Access Compliance Report

Public Rights-of-Way

(Curb Ramps)

Intersection ID: 44453	Main Street: BAYVIEW_PY	Cross Street: RUMNEY_CT	Location: NW
ADA ID: 0ED4616FBC32	Ramp Type: BlendTrans1	Initial Pass/Fail: Fail	Overall Compliance: No
Codes/Mitigation Info/Possible Solution		Field Measurements/Component Compliance	
Severity Score: 8.75

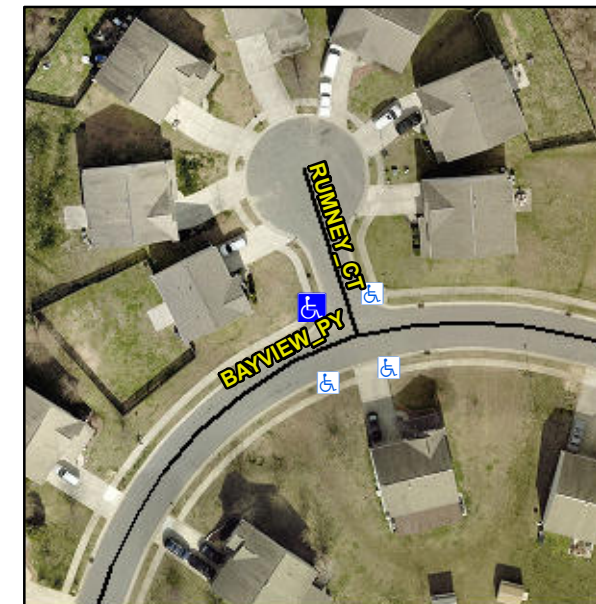
Not Found, R304.5.1

Remove & Replace Curb Ramp With Two New Directional Ramps or Equivalent.
